NOTE TO FILE

JBA Project Code 2017s5531
Contract Stockton Level 1 SFRA
Client Stockton On Tees Borough Council
Day, Date and Time 4 May 2017
Authors Tasmin Fletcher and Kevin Frodsham
Subject Functional Floodplain delineation adjustments

Figure 1: Modelled flood outline for 1 in 25 year event and updated draft FZ3b outline

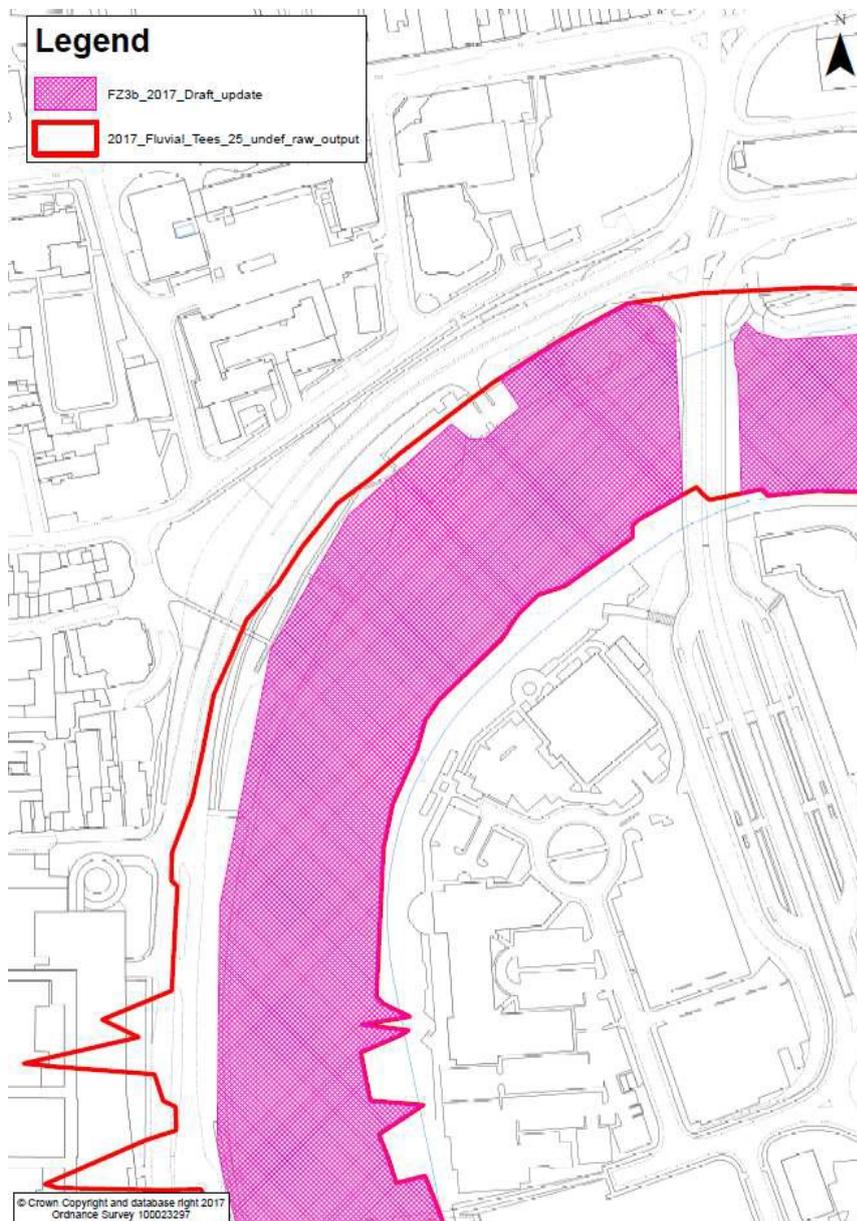
The inclusion in FZ3b of an area on the northern bank, to the west of the Princess of Wales Bridge, has been contested by SBC. This area is shown in Figure 1 below.

Figure 2: 1D model domain setup in relation to LIDAR

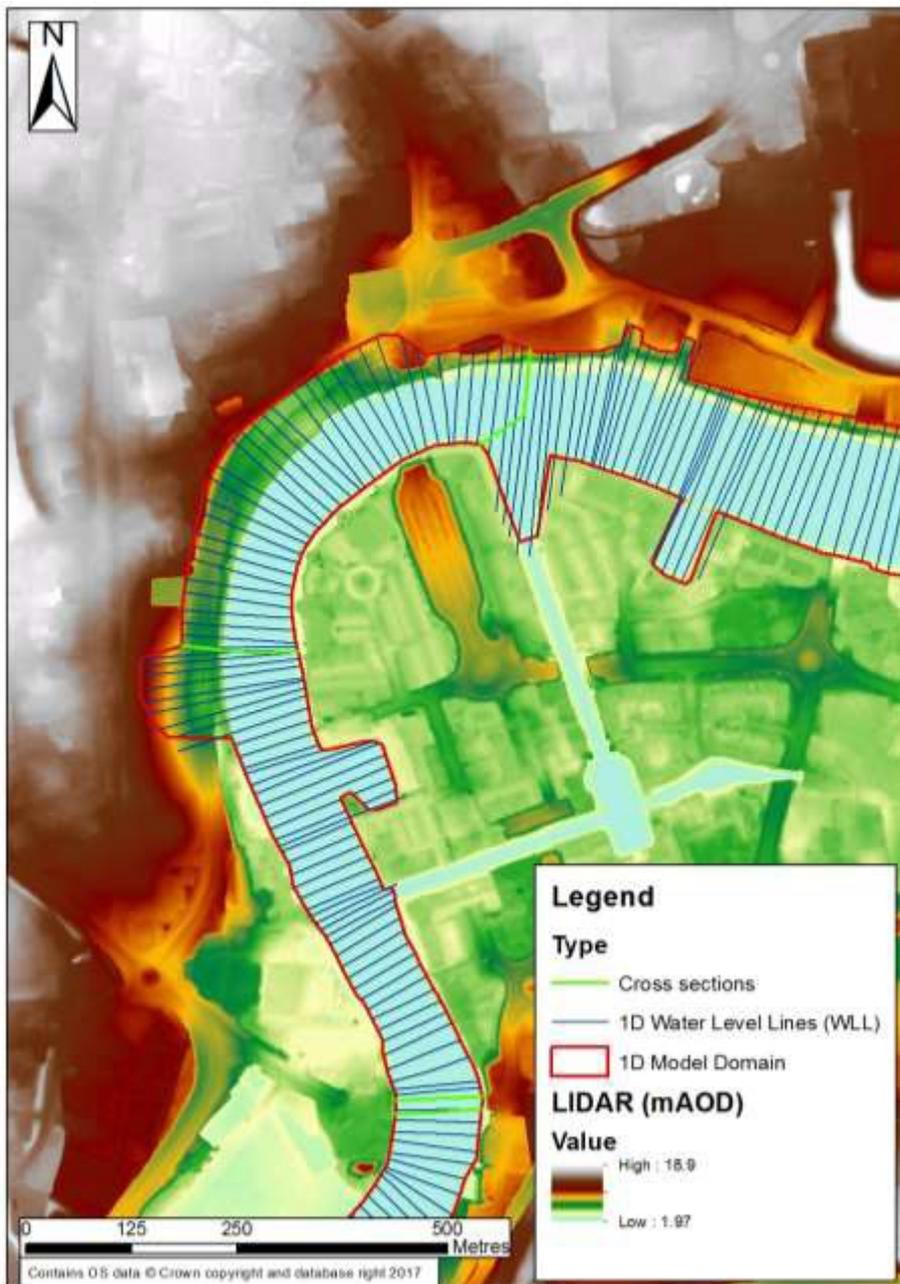
The raw model flood outline extends onto the bank in several locations, notably at the northern bank of the river just upstream of the Princess of Wales Bridge. This output was queried and it was identified that the reason behind the issue is that the 1D component of the model extends beyond the immediate banks of the river to tie into high ground as shown in Figure 2. This may have been an attempt by the original modellers to avoid stability issues. The apparent flooding is actually an artefact of the model configuration whereby the water level from the 1D part of the model is being extrapolated at a low definition across the 1D domain using WLL (water level) lines. Since there are few surveyed cross-sections and a low definition of the WLL lines, the model is projecting the water level to the edge of the modelled channel rather than just remaining in bank.

To correct this, areas of the modelled peak water level grid (m AOD) with values lower than the new LIDAR DTM were identified and removed from the model outline (FZ3b_2017_Draft_updated_final), as shown in Figure 3. These changes highlight the result that there would be no flooding within the urban part of Stockton during this event.
